PUBLIC INTEREST REVIEW FOR GROUNDWATER APPLICATIONS

TO: Water Rights Section Date 06/04/2015  
 FROM: Groundwater Section Phillip I. Marcy / Ivan K. Gall  
Reviewer's Name  
 SUBJECT: Application G- 17962 Supersedes review of \_\_\_\_\_  
Date of Review(s)

**A. GENERAL INFORMATION:** Applicant's Name: Daryl and Joan DeLong County: Malheur

Figure 1: Map showing location of the proposed POA (MALH 2606), in relation to nearby Willow Creek (to the NW).

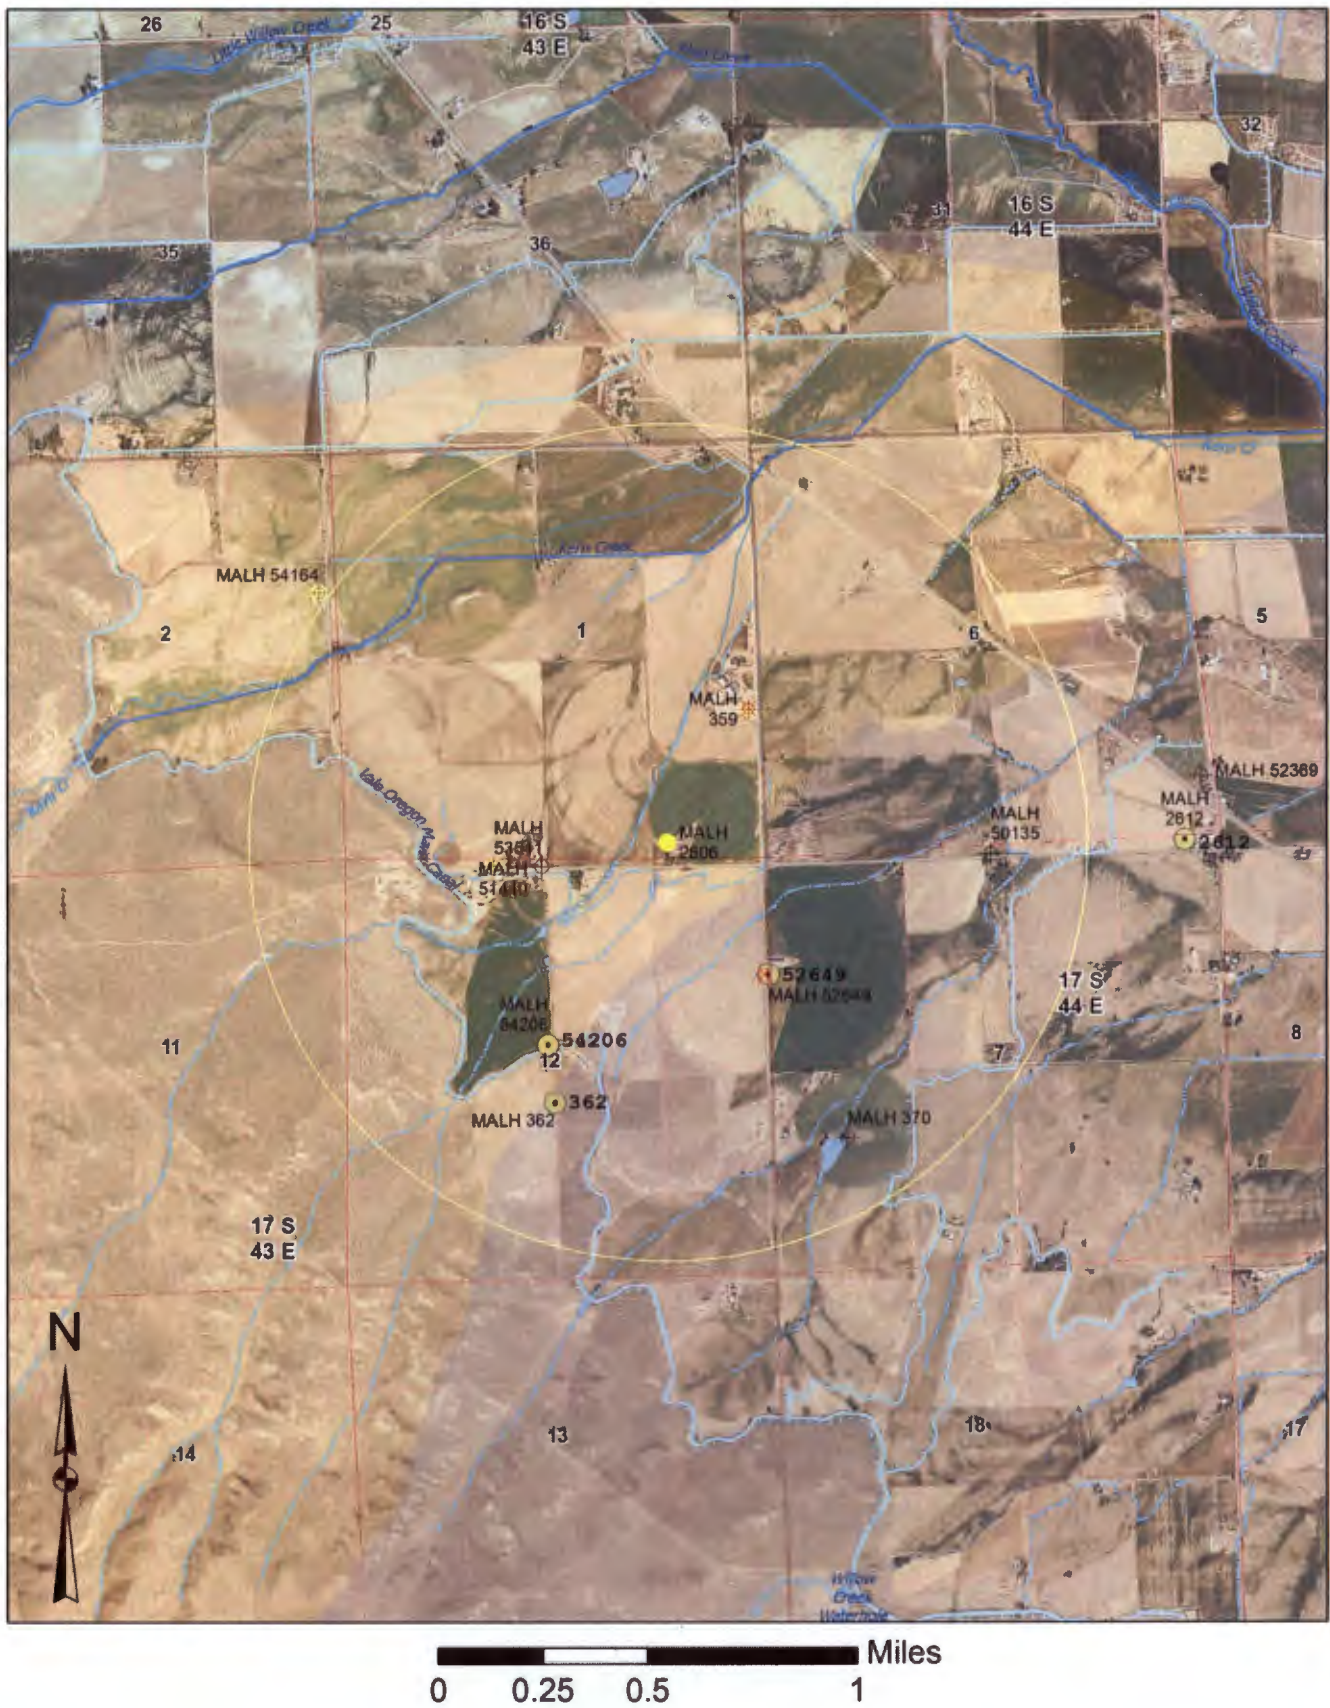
**Basis for aquifer hydraulic connection evaluation:** The perennial reach of Kern Creek begins immediately downslope of the Vale Oregon Main Canal, and is fed primarily by irrigation runoff (personal communication with Ron Jacobs, 05/19/2015) and so will not be evaluated for PSI. The common elevations of surface and groundwater below the canal may exhibit an artificial gradient imposed by canal leakage and infiltration of excess irrigation water. Gannett (1990) indicates the valleys in the Vale-Ontario area are groundwater discharge areas and there is an upward gradient from the Glenns Ferry Formation to the alluvium above which is hydraulically connected to the Malheur River and its tributaries, including Willow Creek.

Figure 2: Groundwater elevations in nearby observation wells have remained stable for decades in this area.

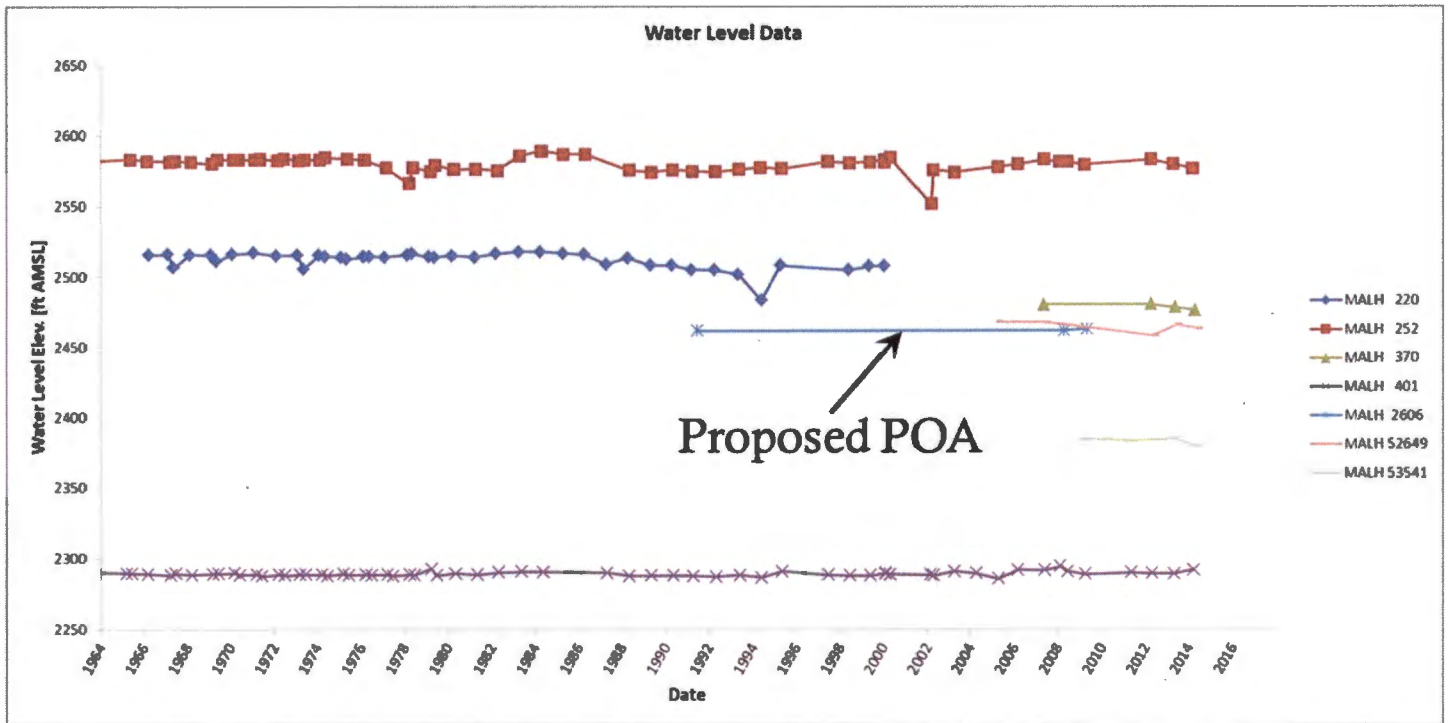
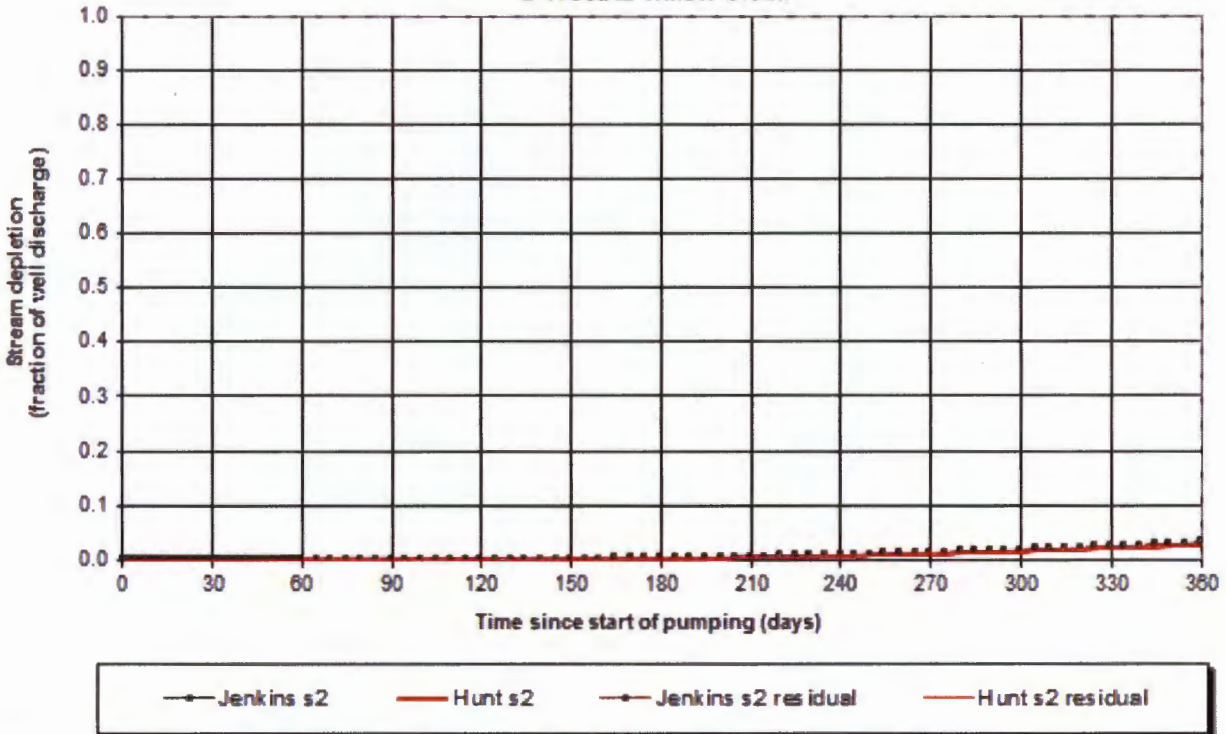
Groundwater elevations in this area have remained stable in wells where long-term records have been maintained (Figure 2). To this point, groundwater development has been fairly limited in this area, and water is likely available without injury to nearby groundwater rights. With limited groundwater data in the area, however, it is difficult to predict the effects of increasing groundwater use. Therefore, the issuance of new groundwater rights should be approached with caution.
